**From:** Victor Grayson  
**Sent:** 13 May 2025 09:09  
**To:** DC Admin  
**Subject:** FW: Planning objection application ref; 2024/60/92168/E

PLANNING COMMENTS  
4th SEPTEMBER 2024

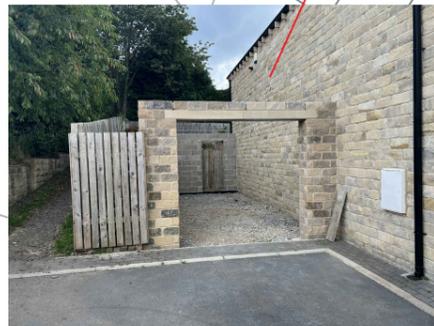
SITE PLAN IS NOT ACCURATE PARTICULARLY AROUND SITE ENTRANCE AREA. PROPOSED PLAN DOES NOT SIT OVER THE OS PLAN PLEASE CONFIRM THAT THE LAYOUT IS BASED ON AN ACCURATE TOPOGRAPHICAL SURVEY

THE RED LINE BOUNDARY FROM THE APPLICATION LOCATION PLAN INCLUDES LAND THAT IS NOT OWNED BY THE APPLICANT – SEE RED HATCHED AREA. THE APPLICANT DOES NOT OWN THE TRACK VERGE TO THE NORTH OF THE SITE AND ALSO THE PROPOSED SITE ENTRANCE INCLUDES LAND THAT IS NOT PART OF THE ADOPTABLE HIGHWAY. THE APPLICATION FORMS DO NOT REFLECT THIS

IMPORTANT ARCHAEOLOGICAL BUILDING TO CORNER OF FILED SHOWN AS DEMOLISHED. WHAT DOES THE ARCHAEOLOGY REPORT/ HERITAGE IMPACT ASSESSMENT BY FARRELL & CLARK (JANUARY 2017?) STATE ON THIS?

HOUSE No. 6B LEAK HALL ROAD HAS PLANNING APPROVAL PARTIALLY IMPLEMENTED INCLUDING HABITABLE ROOM WINDOWS FACING THE APPLICATION SITE. PLOT 12 THEREFORE NEEDS MOVING 11m AWAY FROM THIS AS PER KMC POLICIES

PARTIALLY IMPLEMENTED [EXTANT] PLANNING APPROVAL REF 2022/92068 WITH HABITABLE ROOMS FACING THE APPLICATION SITE

DUE TO INACCURATE SITE PLAN, DIFFICULT TO PORTRAY THE EXTENT OF THE SITE ACCESS PROJECTING PAST THE END OF THE ADOPTABLE HIGHWAY - ESTIMATED AT APPROXIMATELY 3-5m INTO 3RD PARTY LAND

IMPORTANT PINFOLD BUILDING SHOWN AS DEMOLISHED - WHY IS THIS NOT RETAINED?

SUB-STANDARD VISIBILITY SPLAY. 30mph ROAD NEEDS 2.4m X 90m SPLAYS AND IT IS IMPOSSIBLE TO ACHIEVE THIS SAFELY WITHIN HIGHWAY STANDARDS GIVEN THE CURRENT SITE ACCESS LOCATION

EXISTING WALL AND TREE RESTRICTS CRITICAL VEHICULAR SIGHT LINE ACROSS 1.9m FOOTPATH
